Wylfa Newydd DCO Examination

DCO Issue Specific Hearing (ISH) – Dafydd Griffiths on behalf of the NACP

Traffic and Transport – Non-Motorised Users (NMU)

Valley Area

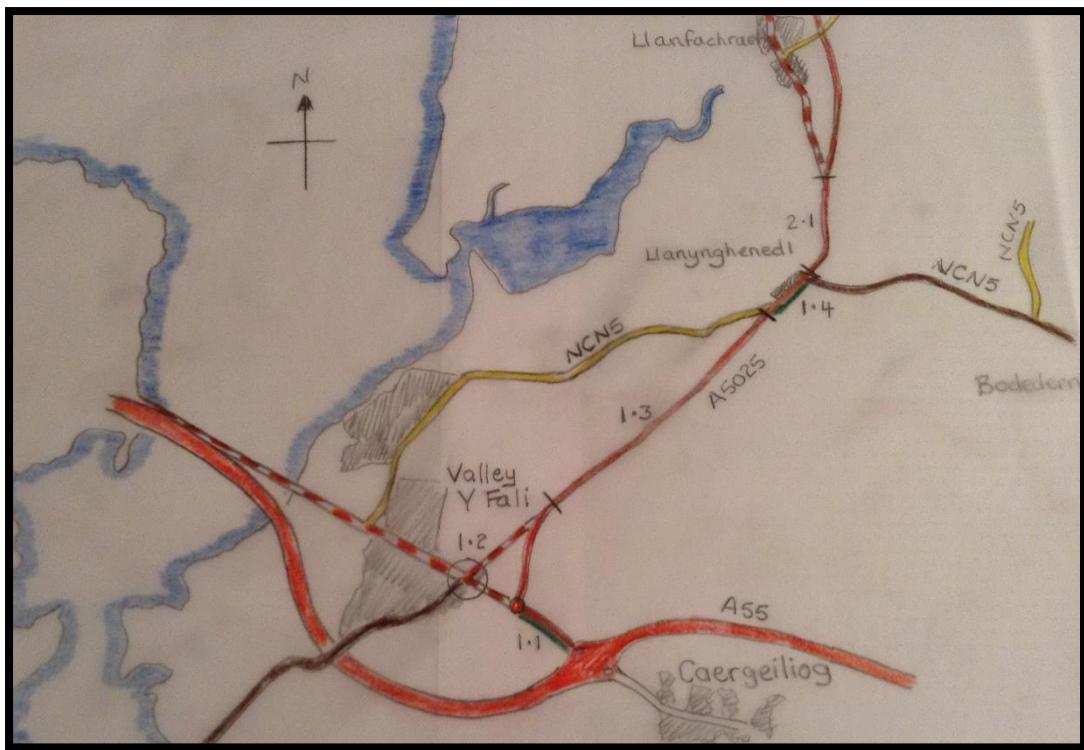
New Valley roundabout area (1.1 on diagram)

The NACP's first area of concern is the proposed NMU infrastructure south east of the proposed new roundabout at Valley on the A5. Both the original DAS (APP-410) and the revised version 2 (REP2-030) reference the following as the applicant's response to Stage Two Pre-Application Consultation.

A note in the current plans as submitted indicate the following "EXISTING FOOTWAY TO REMAIN AND BE REDESIGNATED AS SHARED FOOTWAY" (APP-019 - WN0902-HZDCO-OHW-DRG-00002). On the 6th January 2019 the footway on this section was measured at several locations. The majority is between 1.8 and 1.4m wide and does not meet the standard that would be expected of a two way shared cycleway / footway. "The preferred minimum width for an unsegregated facility is 3.0m." However, "unsegregated shared facilities have operated satisfactorily down to 2.0m wide with combined pedestrian and cycle use of up to 200 per hour". (Design Manual for Roads and Bridges DMRB Volume 6, Section 3, Part 5, 7.16)

The use of the phrase "away from the carriageway edge" is misleading. What appears to be proposed is simply re-designating the narrow footway that runs between the two roundabouts as a cycling / pedestrian path.

Examining the drawings as submitted it is not clear what is proposed as NMU infrastructure between the new roundabout and the Valley traffic lights.

The current proposals are unacceptable and further appropriate mitigation is required.

Valley Traffic Light junction (1.2 on diagram)

The Road Safety Audit proposal recommends the following – “positively direct all cycle traffic along the old A5025”. It is not clear what modifications are proposed to the traffic light phasing at Valley junction, how the lights would be triggered by cyclists and how it is envisaged that cyclists would interface with the cycle infrastructure proposed in 1.1 above.

The NACP seek further clarification on this matter.

Valley link to Llanyngchedl (1.3 on diagram)

The applicant's current proposals enable cyclists and pedestrians to make use of the 'old' section of the A5025 from the Valley Traffic Lights in the direction of Llanyngchedl. The proposals provide a cyclist / pedestrian 'crossing point' where the new Off-line section meets the A5025 towards Llanyngchedl. During the 10 year construction phase the proposal requires cyclists and pedestrians to share the carriageway with an increased volume of A5025 motorised traffic over a 1.5km section of the A5025. It could be argued that additional provision on this route duplicate the NCN Route 5 between Valley and Llanyngchedl. However, NCN Route 5 skirts the north of Valley. The potential new route links directly to the main shopping area in Valley and a direct route in the direction of Caergeiliog.

It is the NACP's view that the lack of a cycleway / footway in the current proposals are unacceptable and further appropriate mitigation is required.

Joint use footway / cycleway at Llanyngchedl (1.4 on the diagram)

The NACP note the drawings of the proposed joint use cycleway / footway that form part of NCN Route 5 at Llanyngchedl. Drawing WN02.05-ACM-S2-00-DRG-003¹ has two 10 m sections of limited width (1.5m and 1.2m) due to the current location of two electricity poles that also light the area. It is the NACP's view that it would be more appropriate for the applicant to arrange for the poles to be relocated at the earliest opportunity to facilitate a minimum 2m width along the full length of this facility.

Llanyngchedl to Llanfachraeth (2.1 on the diagram)

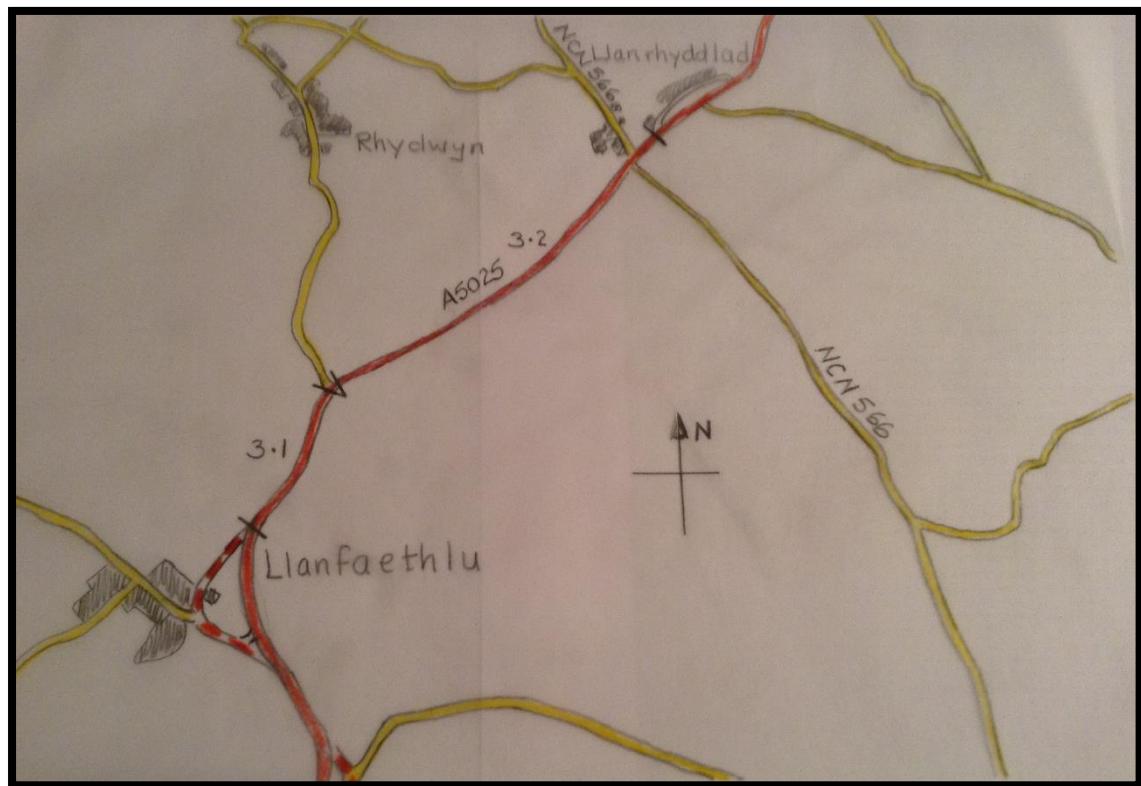
In the summer of 2018 the NACP became aware that footway / cycleway provision between Llanyngchedl and Llanfachraeth had been discussed at a meeting on 5th July 2016 to present Horizon's Cycling Position Statement to IACC and Sustrans. The meeting note records two key issues that were raised but it does not record who raised these matters.

The NACP draw the panel's attention to Llanfachraeth being within Active Travel cycling distance of Valley and Holyhead. Both are designated localities under the Active Travel (Wales) Act 2013.

The NACP note that Bodedern is only about 250m from the route of NCN Route 5. A link between Llanfachraeth and Llanyngchedl would create the link to Bodedern.

The applicant notes that Llanfachraeth is within Active Travel distance of Valley and Holyhead. But under the current proposals Active Travel users would have to use the main A5025 carriageway when travelling between the outskirts of Llanfachraeth and Llanyngchedl. The applicant's documentation notes that the volume of traffic will increase significantly, that the traffic will be travelling faster and that traffic will have a higher percentage of HGVs and buses than currently experienced. There are no appropriate alternative routes that Active Travel users could use for the journey.

It is the NACP's view that the current proposals are unacceptable and further mitigation is required.

Llanfaethlu link to Rhydwyn / Llanrhuddlad (3.1 on diagram)

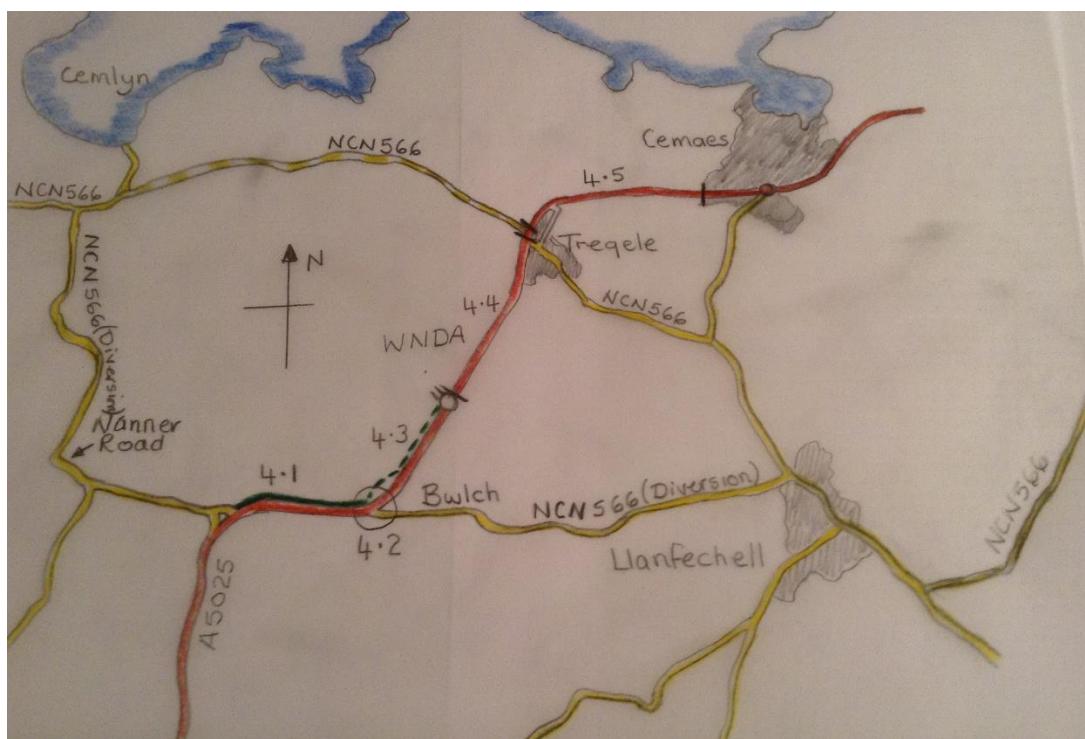
At 4.3.52 the applicant has identified that consideration must be given to Active Travel when considering new highway schemes and has assigned a high value for travel from Llanrhuddlad / Rhydwyn to Llanfaethlu (Ysgol Rhyd y Llan). The distance from Ysgol Rhyd y Llan to Rhydwyn and Llanrhuddlad are within 2 miles of the new school. Therefore, the provision of free transport under the 2 mile category would not apply. IACC education department may have made an exception but the NACP are not party to that information. The confusion may be due to the old school at

The distance between the northern end of the section 5 off-line improvements and the turn off for Rhydwyn is approximately 700 metres. Llanrhyddlad is a further 1500 metres.

In addition, the northerly exit from the 'old' A5025 at Llanfaethlu notes a 'proposed gate to maintain pedestrian access to the village'. It is the NACP's view that this gate must also be designed to accommodate the passage of cycles. (APP-021)

The applicant notes that both Rhydwyn and Llanrhyddlad are within Active Travel distance of Llanfaethlu. Under the current proposals Active Travel users would use the main A5025 carriageway when travelling from Llanfaethlu to Rhydwyn / Llanrhyddlad. The applicant's documentation notes that the volume of traffic will increase significantly, that the traffic will be travelling faster and that traffic will have a higher percentage of HGVs and buses than currently experienced.

There are no appropriate alternative routes that cyclists or walkers could use for the journey.

It is the NACP's view that the current proposals are unacceptable and further mitigation is required.
